# Range Rover Sardinia Cup

## Equipment Substitution Request

Request No: 06

Boat: Sardinia Cup - SC 1 - GBR 51X - Django wr - Ettore Botticini

[c85790fb-74b2-4e79-993e-99e37c737d09.jpeg](#) 710 KB

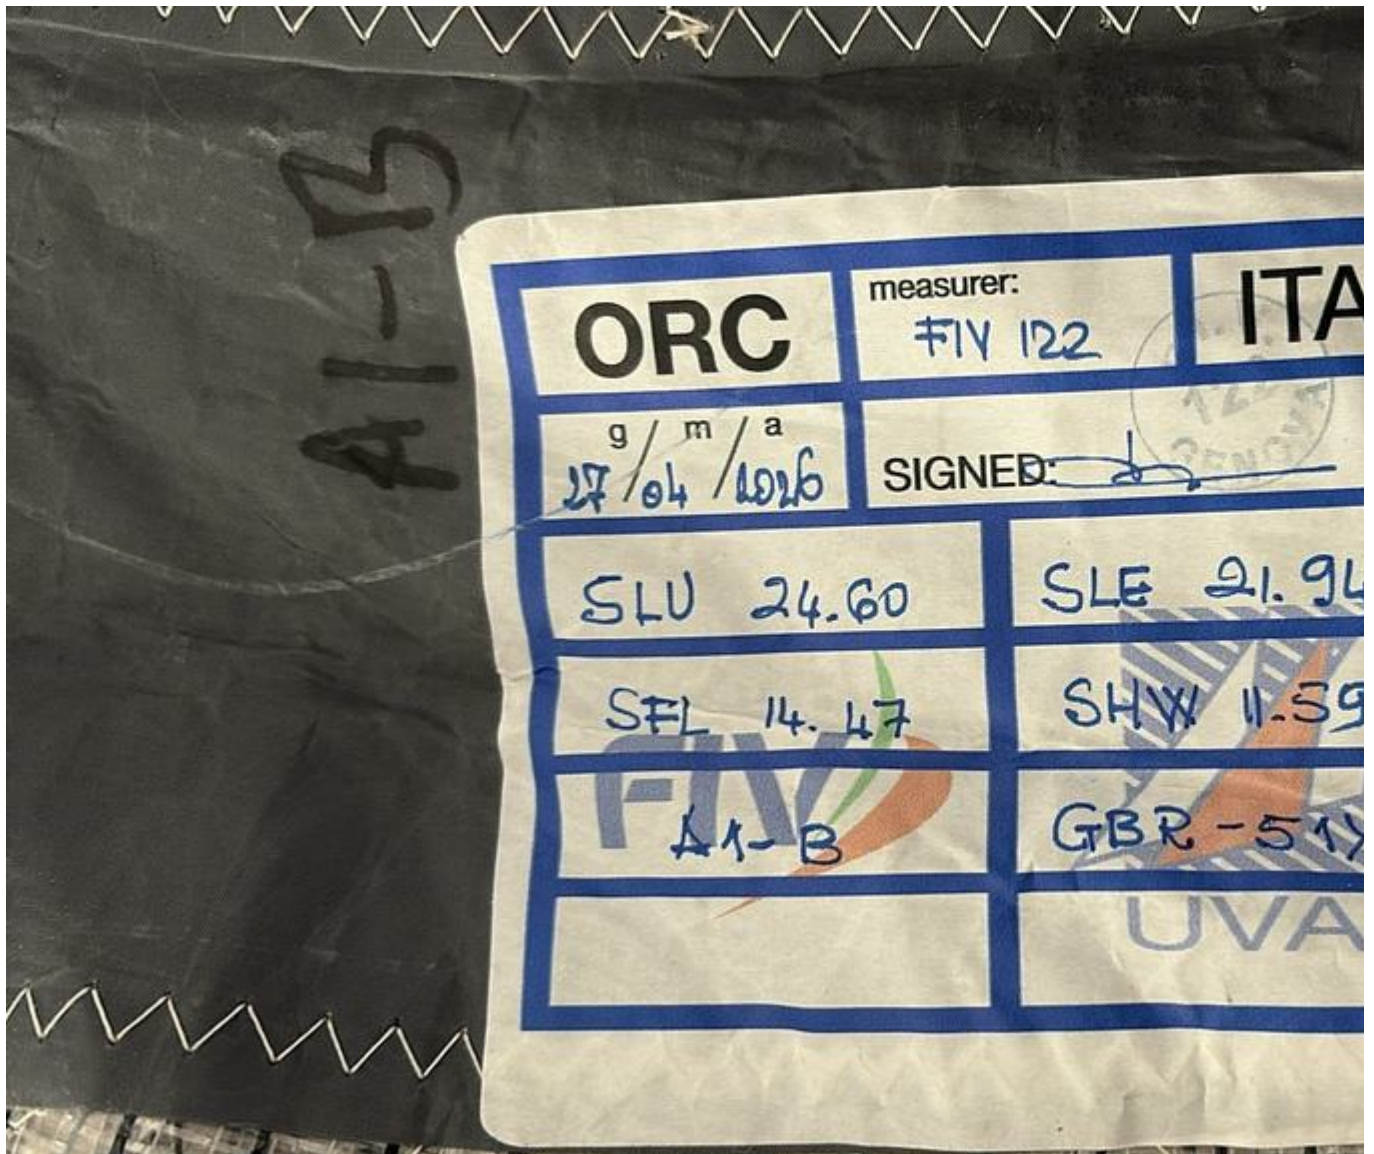
As per previous communication we are requesting to replace our A3-1 with our A1-B in our sail inventory.

Attached you can find the A1-B stamp which shows that the new kite is compliant with our current certificate.

**Response: Not Approved**

Any replacement of a sail should only be with one of the same code and SFL:SMW ratio and similar size.
